# Body Link Sweater Ltd. Marigold Accessories Ltd.

Plot No. 371, 342, Noljani, Chandona, Joydevpur, Gazipur  
(23.990786N, 90.389874E)

15<sup>th</sup> March 2015

# Observations

# High stress levels in columns

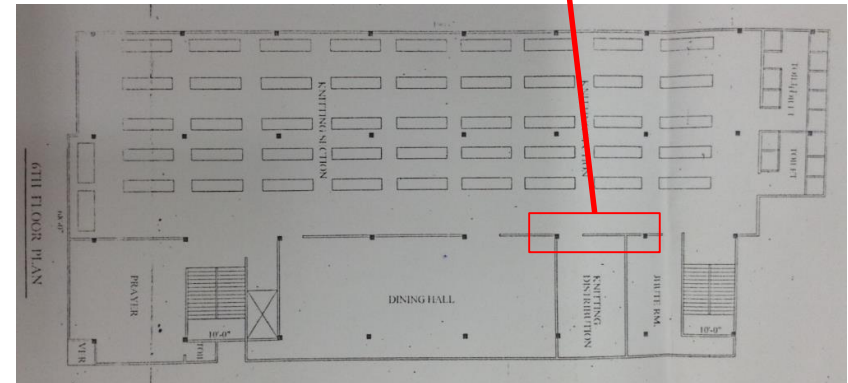
Column supporting cantilever

Column under water tank

Cursory calculations indicate high column stress in columns, particularly those supporting cantilever and under water tank

# Discrepancies between composite roof design and as-built condition

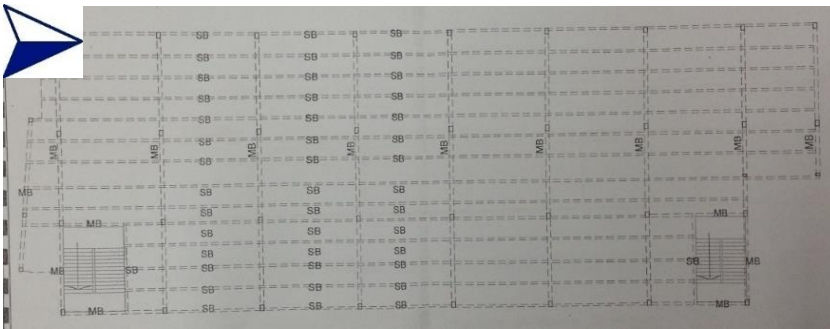
As-built: Primary N-S, purlins E-W direction

Primary beam missing: brick wall is load bearing

Design: Primary E-W, purlins N-S direction

# Lateral load transfer from composite roof to perimeter beams

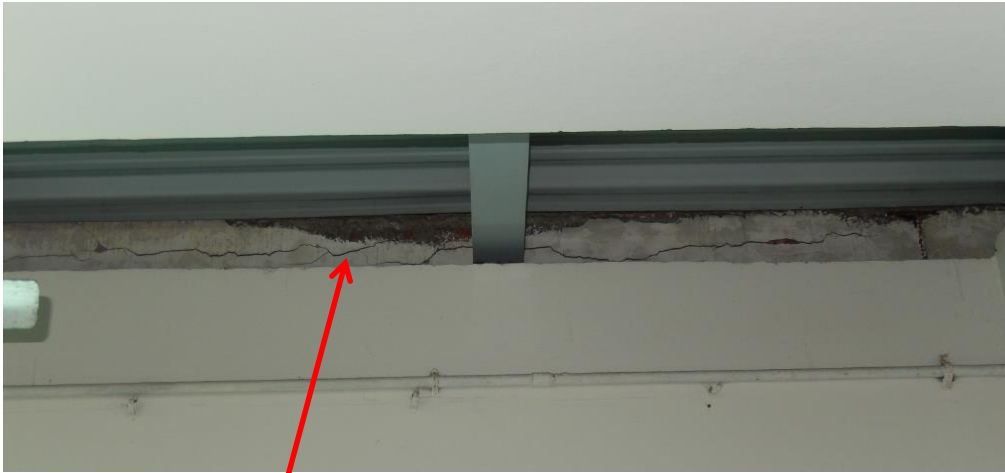
Cracking observed between roof deck and brick wall

No anchorage detected between roof deck and concrete beams

Lateral load transfer from composite roof onto concrete frame is unclear

# Damage to columns and beams

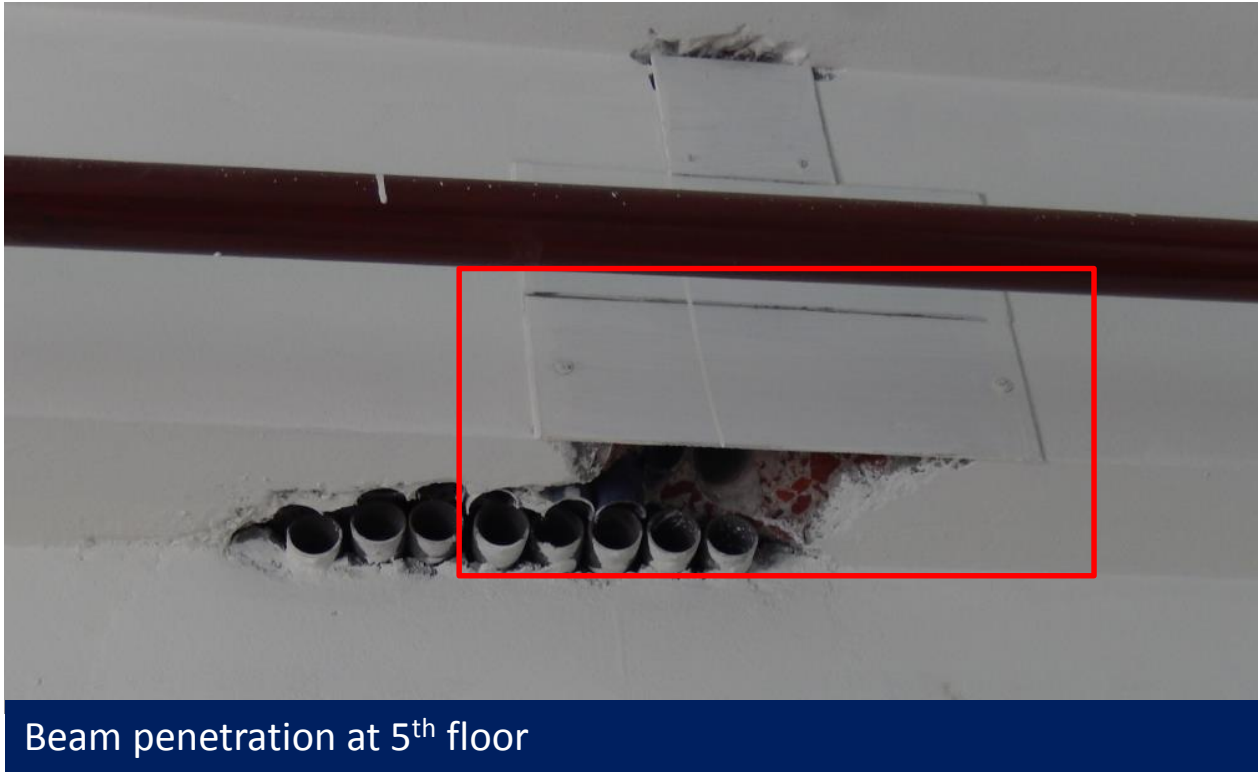
Three or more of the reinforcement bars in the column appear to be cut

Columns under water tank are damaged  
- Review required

Beam penetration at 5<sup>th</sup> floor

5<sup>th</sup> floor beam is damaged  
- Review required

# Non-engineered roof in generator and boiler buildings

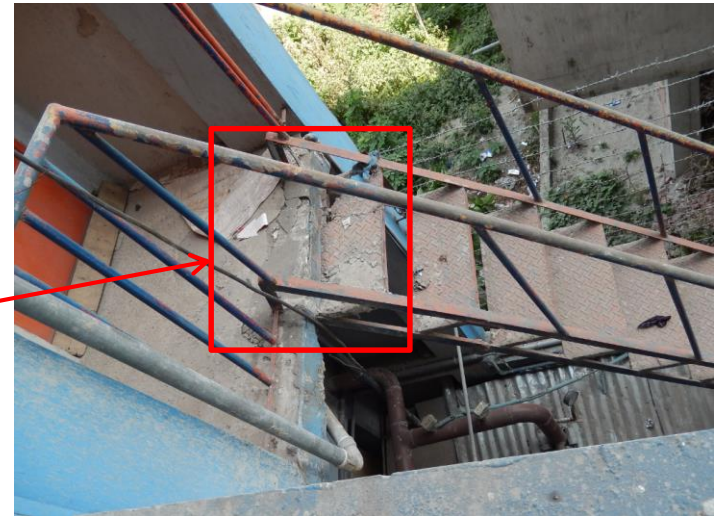
Metal sheet with concrete fill in generator building

Metal deck in boiler building

Non-engineered roof in generator and boiler buildings
